**ZLIN AIRCRAFT a.s.**  
Letiště 1578, 765 81 Otrokovice,  
Czech Republic  
e-mail: [zlin-service@zlinaircraft.eu](mailto:zlin-service@zlinaircraft.eu)  
<http://www.zlinaircraft.eu>

**MANDATORY BULLETIN Z 242L/10a**

2. **SUBJECT:** Unification of Manuals and application of an identical maintenance system for the Z 242L airplanes.
3. **CORRECTION:** 3.1 Replacement of the airplane Manuals by following ones, containing Revision No. 1 and all subsequent Revisions prescribed in corresponding Mandatory Bulletins (at the date of issuance of this Bulletin the following Mandatory Bulletins are applicable: Z 242L/12a (Z 242L/12a - Rev. 1), Z 242L/13a, Z 242L/14a and Z 242L/16a).

Fig. 1

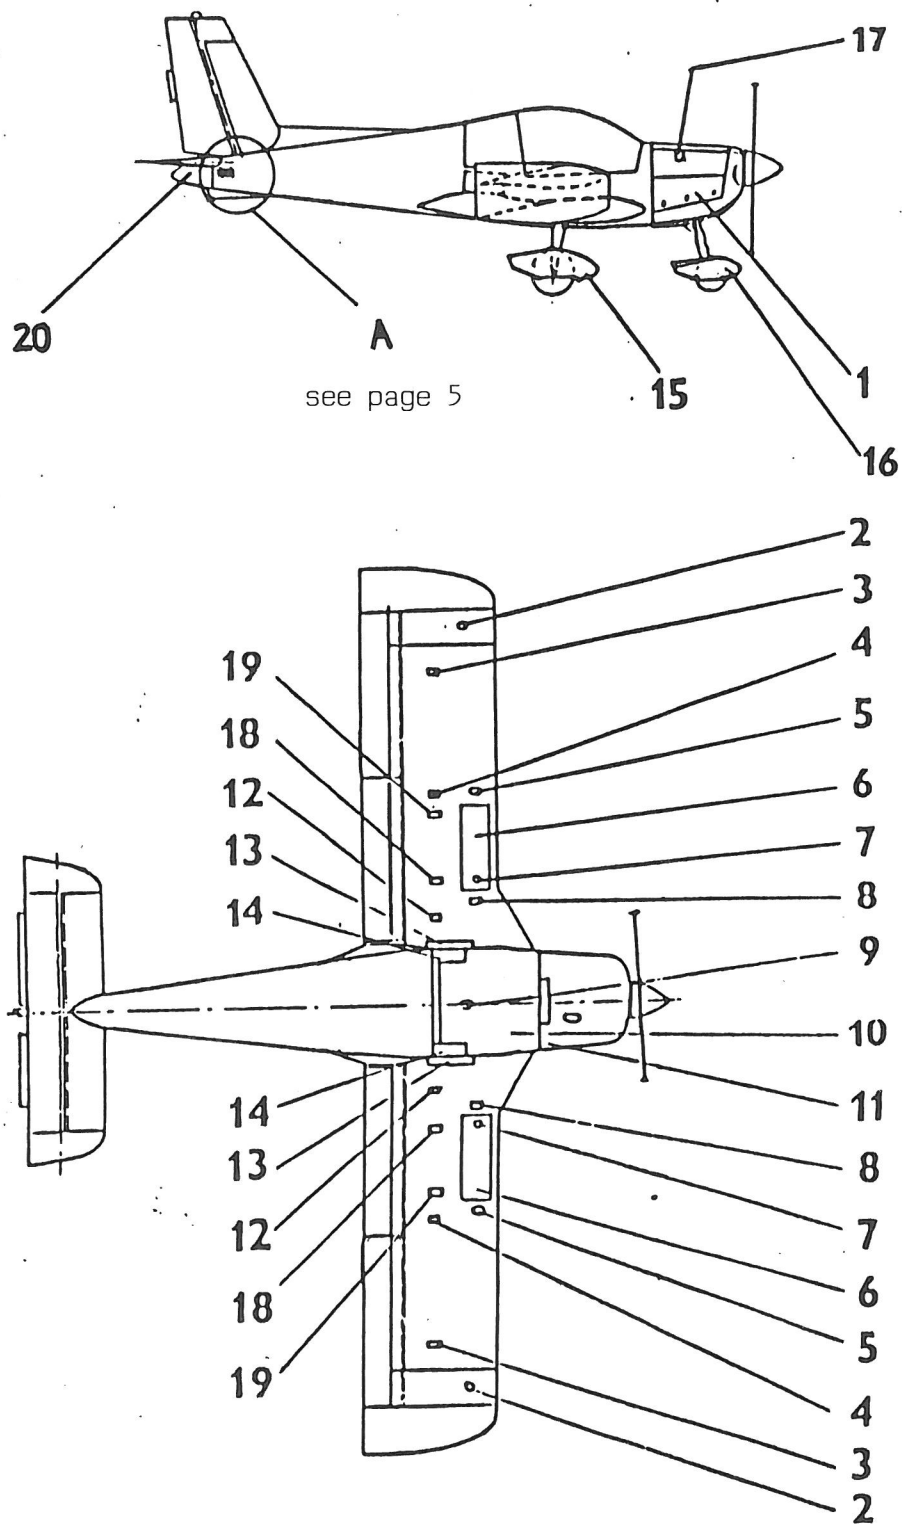
- i. Survey the four holes in the bottom skin of the l.h./r.h. wing behind the main spar between the ribs No. 3-4 and 6-7 respectively - see Fig. 1 through 3. Adjust the lid according to the survey and mark out the shape of the holes on the skin. Cut-out the holes carefully, use the rotary file to finish the correct shape.

See Fig. 1 and 5.

Fig. 2

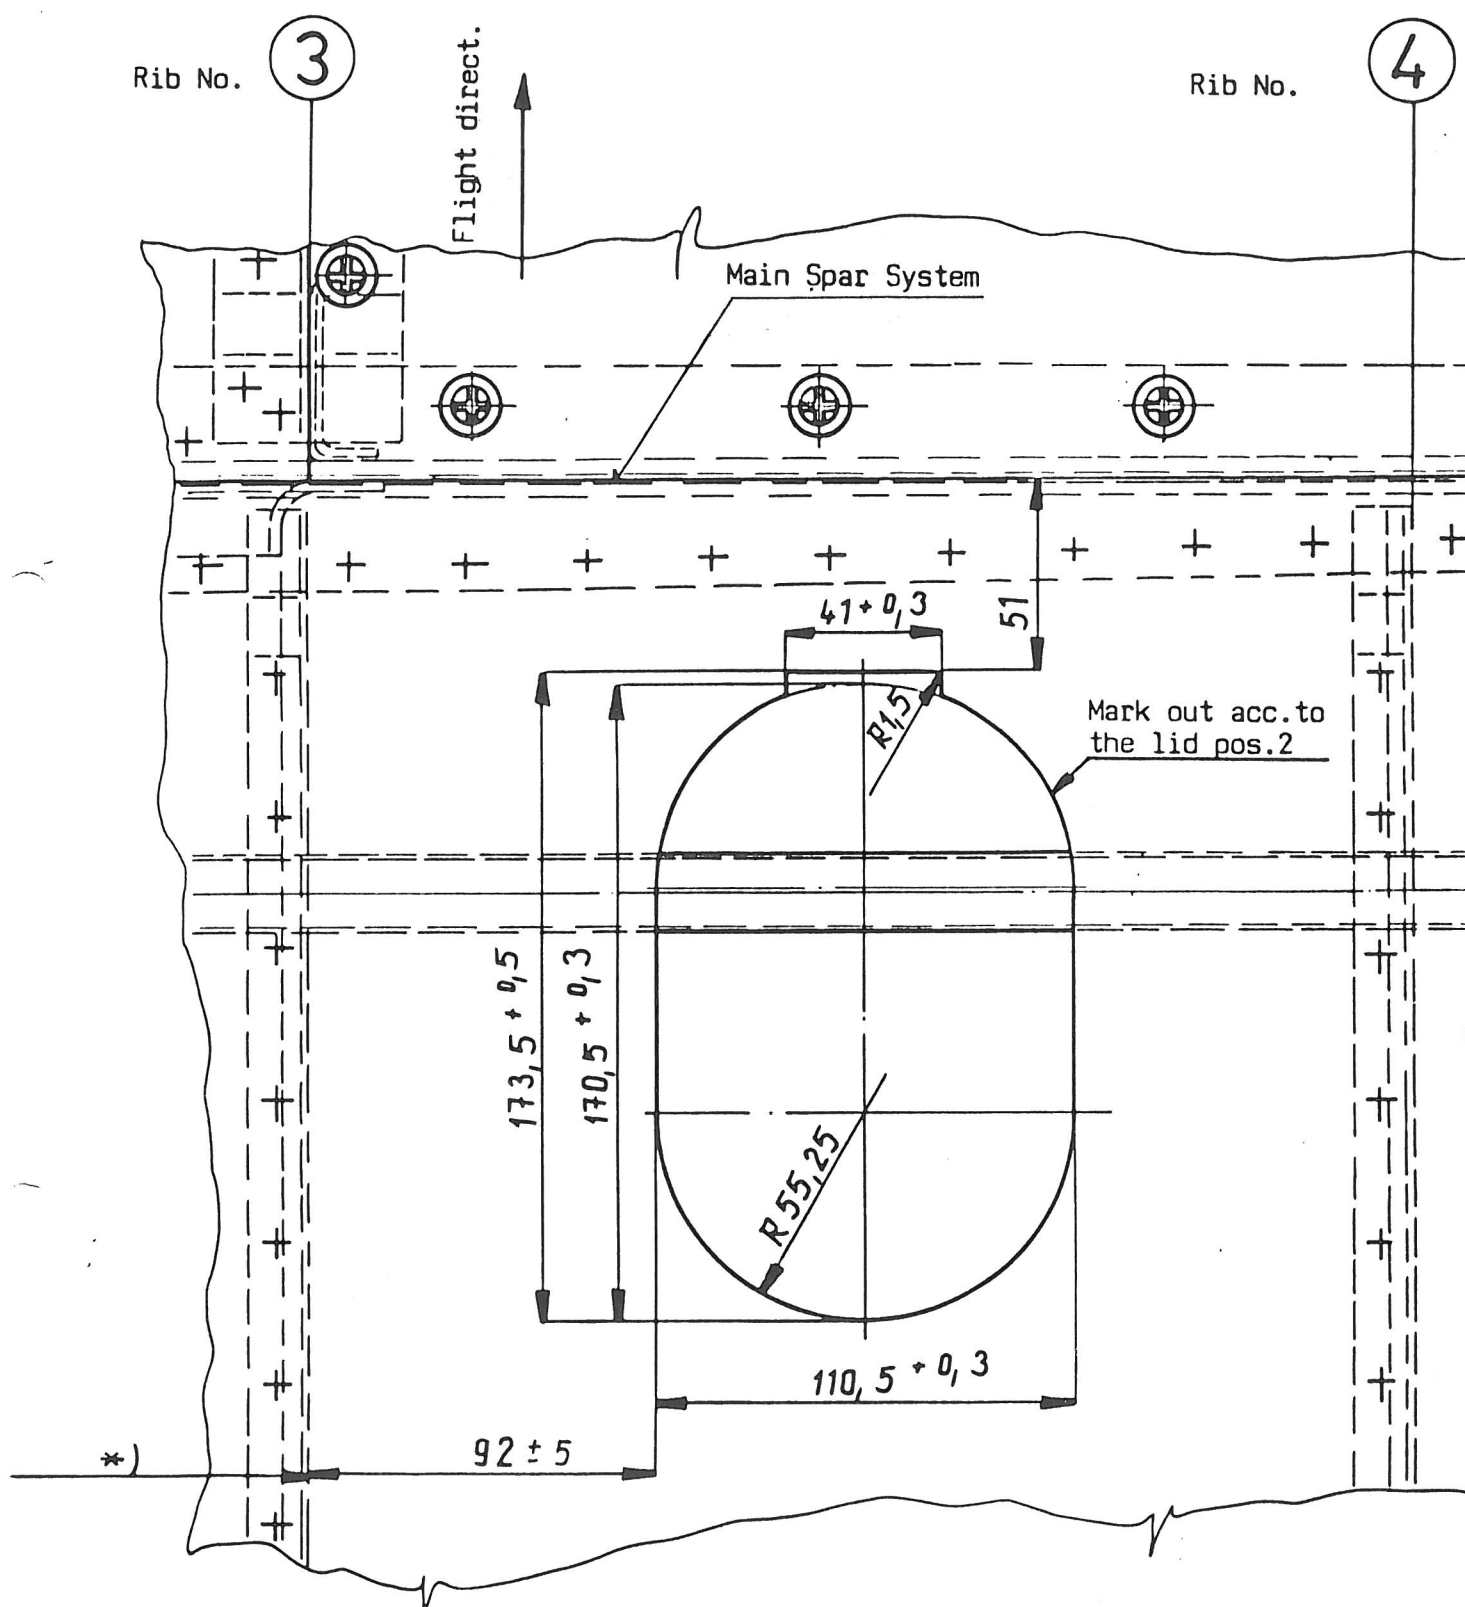
Avoid the possible damage of inner parts during the cutting-out procedure! The lid spanwise positions, measured from the ribs No. 3 and 6 or from the centre of low hinge, are to be hold on the nominal values, shown in Fig. 2 and 3, in allowed tolerance  $\pm 5$  mm.

Sect. A - A  
M 1:1

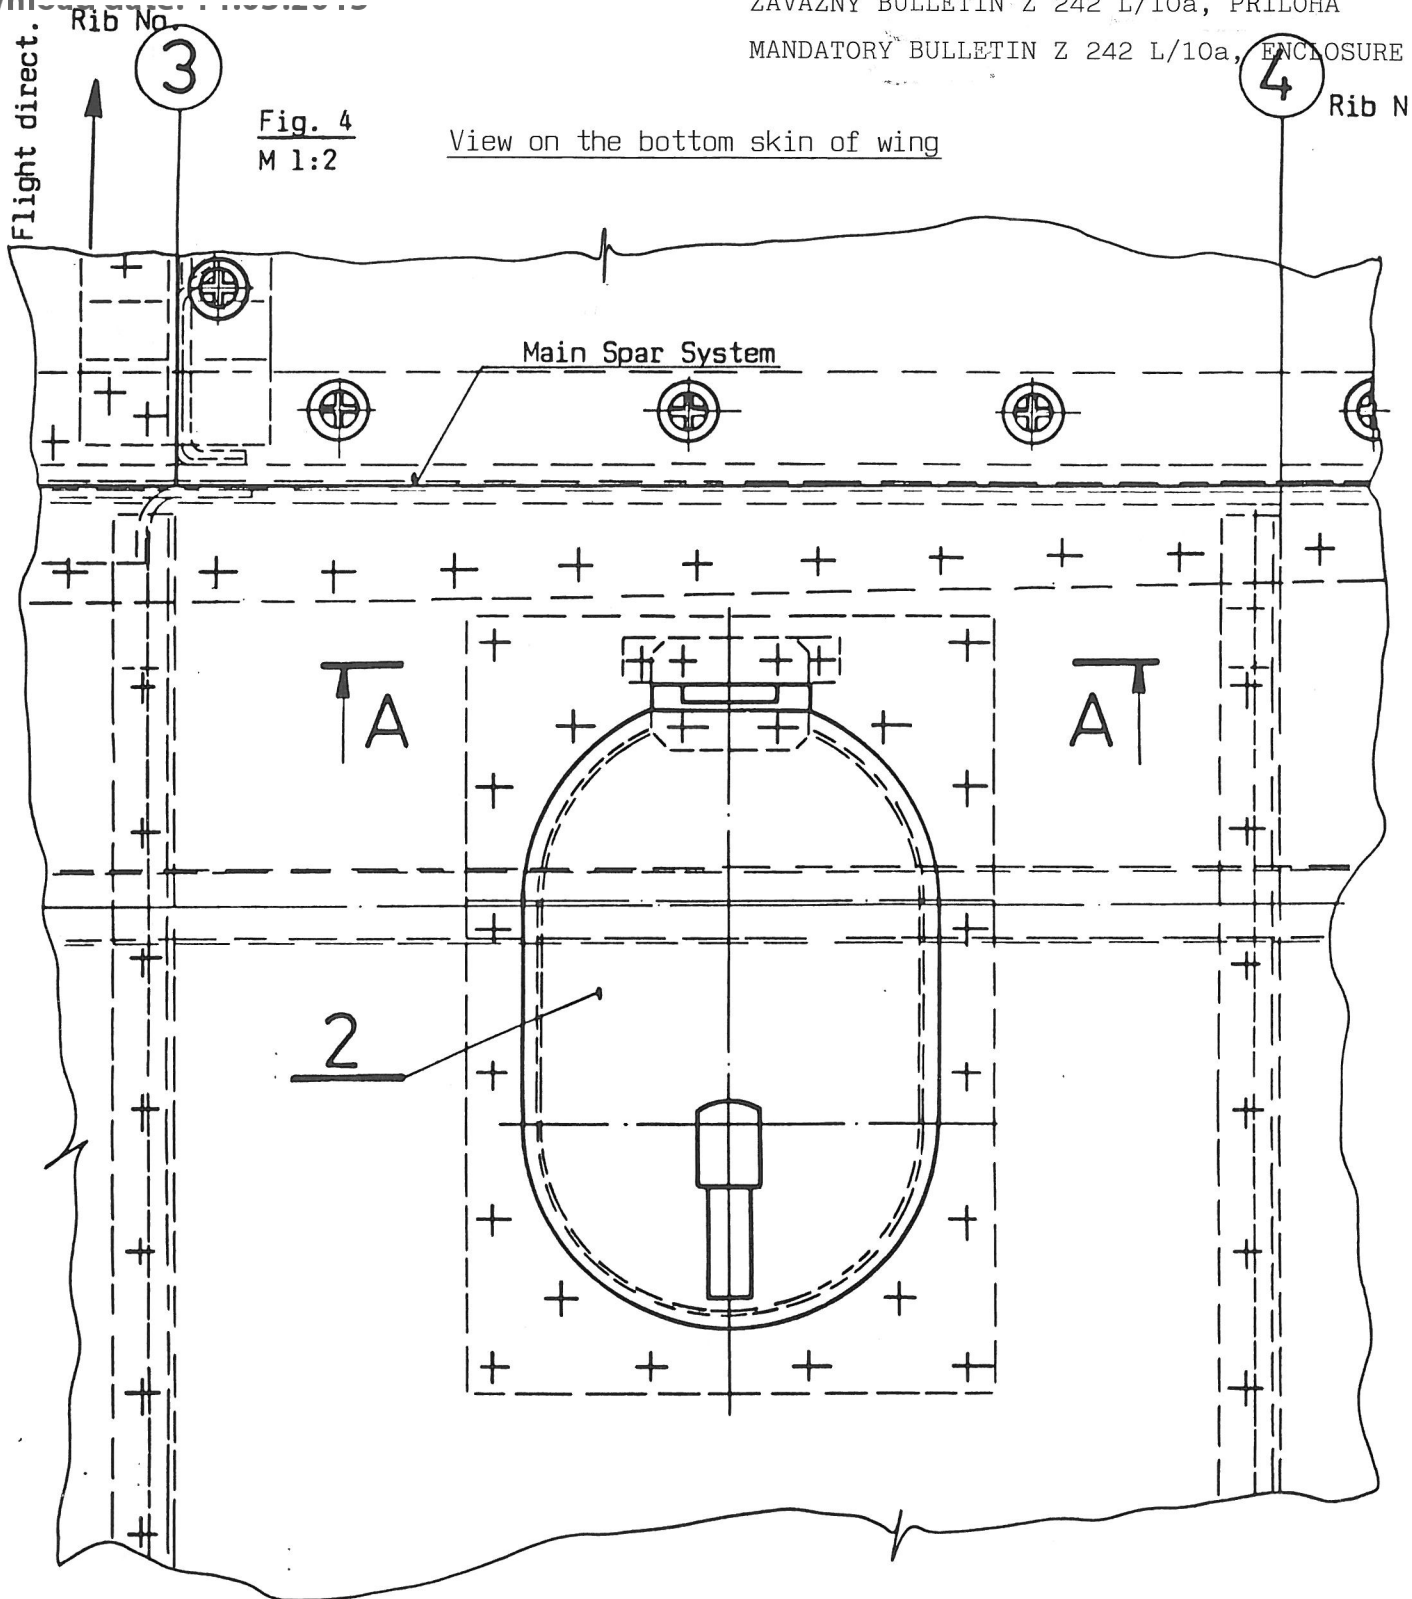
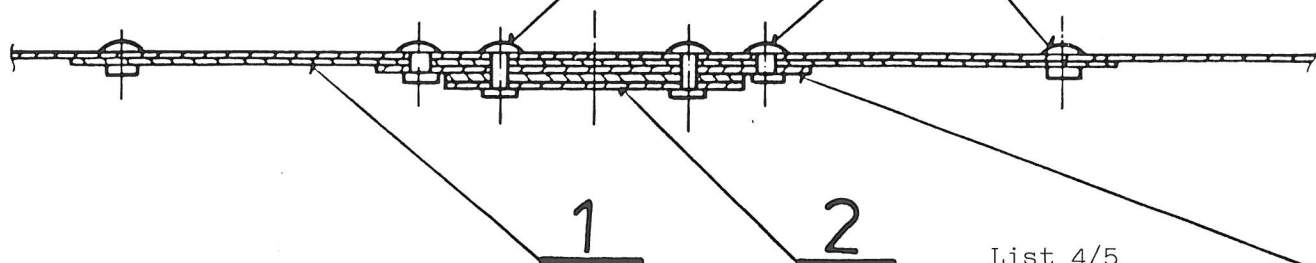
- ii. Adjust and clamp the framing on the outer side of skin, with the framing hem inside the hole and predrill 18 holes, 2.1 mm dia into skin.
- iii. Adjust and clamp by appropriate clamps the framing into the hole according to predrilled 2.1 mm holes, redrill the 18 holes on 3.1 mm dia and rivet the framing by 18 DuV 3x5 mm rivets.
- iv. Adjust the lid pos. 2 with the strap plate pos. 3, according to Fig. 4 drill two holes 3.1 mm dia and 2.7 mm dia each, rivet 2x DuV 3x6 mm and 2x DuV 2.6x7 mm (Fig. 4 is applicable both for pos. 18 and 19 lids).
